Staff Report for Item 12a

Application Number: H15-01-0006

Address: #1321 South Street

New two story buildings.

PROPOSED FRONT ELEVATIONS W/ ADJACENT PROPERTIES SCALE: NTS

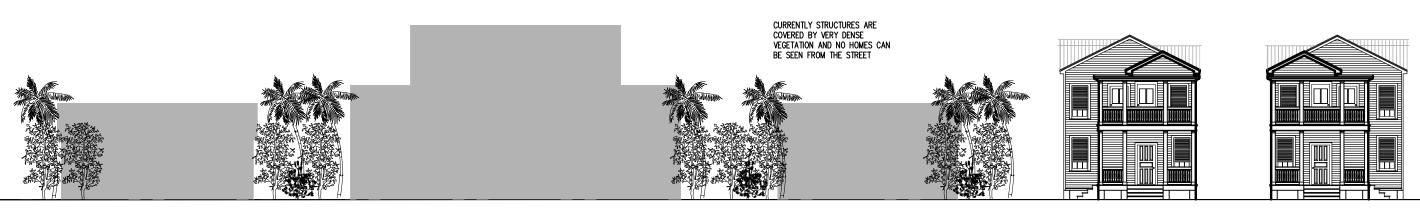
- 1. Although the proposed structures are wider than many surrounding houses in the area they will exceed the height established by the majority of the buildings. The proposed design fails to comply with the guideline for height for new construction.
- 2. The proposed proportions and massing of the houses are not in keeping with the majority of surrounding structures. The width and height of both structures in relationship to their site and surroundings is not similar to proportions of buildings and sites found within the urban context.
- 3. The proposed building materials and textures are compatible with the historic character of the district.

It is staff's opinion that the design proposes two buildings that will exceed the established height in the area. Although the site is located in the boundaries of the historic district massing, height and proportions are still elements that need to be considered for any new proposed construction. Staff has expressed these concerns to the applicant. It is staff's opinion that the new proposed plan is not appropriate to the site due to the design's mass, scale, height and proportions.

SITE PLAN 1/8" = 1' - 0"

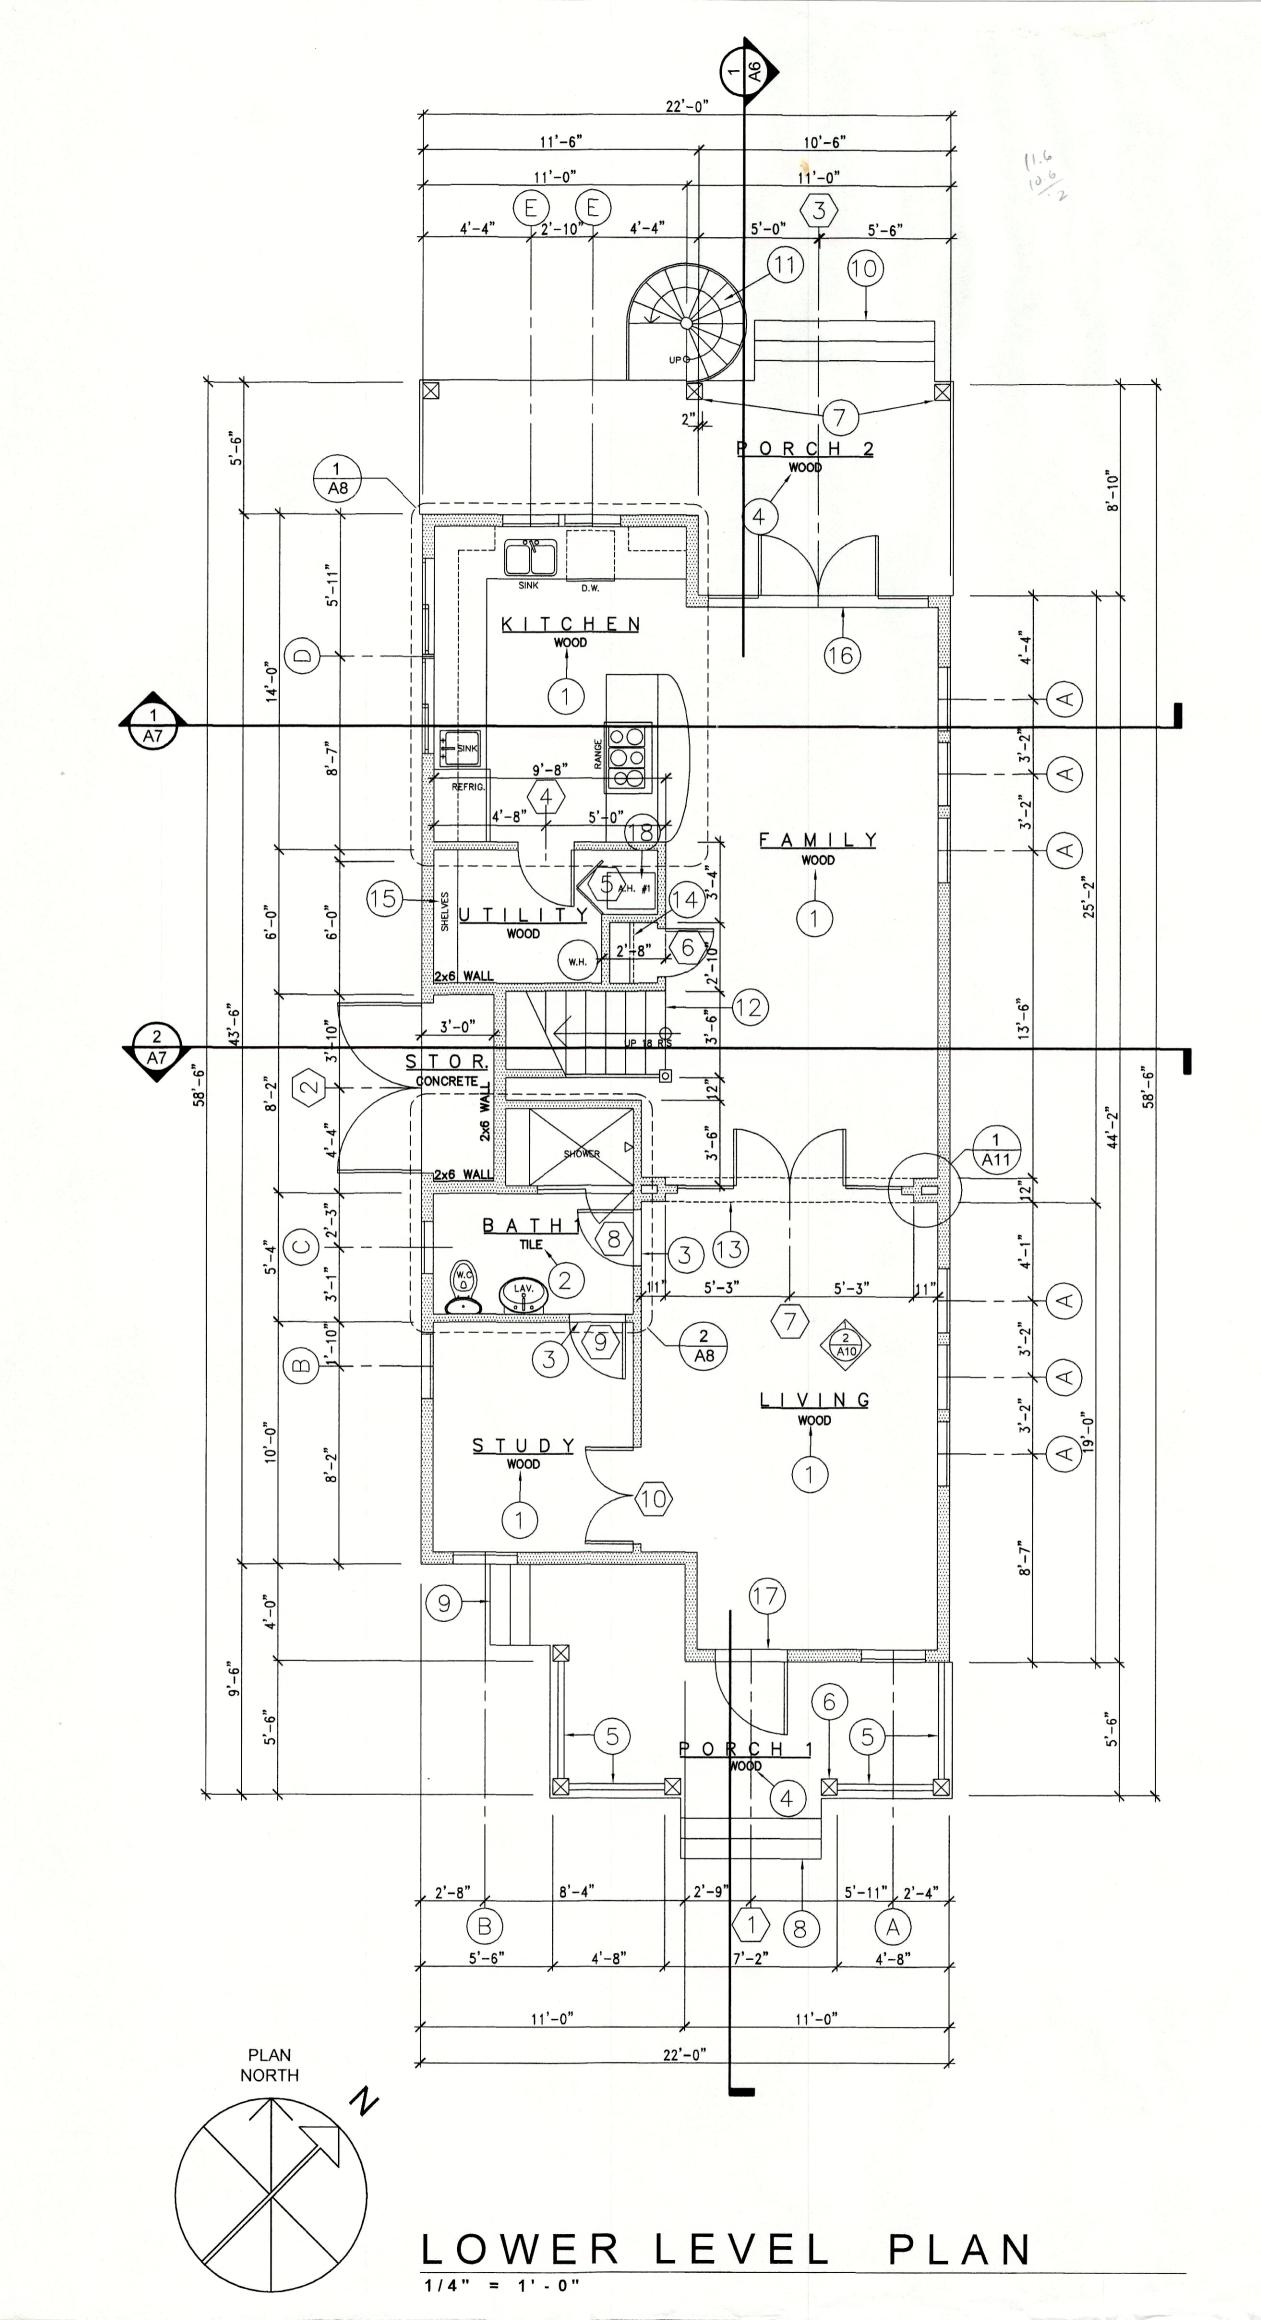
- Ms. Eables stated that they were replacing because of flooding.
- Mr. Batty asked if there was any reason why they were going with a bigger fence rather than something smaller.

- Mr. Knoll stated because it was traditional.
- Mr. Batty stated that no it's not.
- Mr. Mancini stated that it should be decorative. He stated that people do such a wonderful job and then cover up so you can't see it.

- Mr. Knoll stated that he doesn't want to be argumentative. He stated that standing in front of 4 ft. fence you can see over.
- Mr. Batty stated that was true but from the center of the street you can't see the porch. He stated that traditionally all fences remain at 36 in. or lower. He stated that he feels strongly about this because it is a part of the Historical District that it getting lost.

- Mr. Knoll stated that his client was willing to comply with that.
- Mr. Batty stated that they try to stay clear of the maximum and brining it to 36 in. would make them very happy.

Mr. Batty made a motion to approve with changes of fence reduced to a height of 36 in.

APPRO	VE	X with	changed	of fence	to a	reduced	height	of 36
inches	DISAPPROVE	TAE	BLE
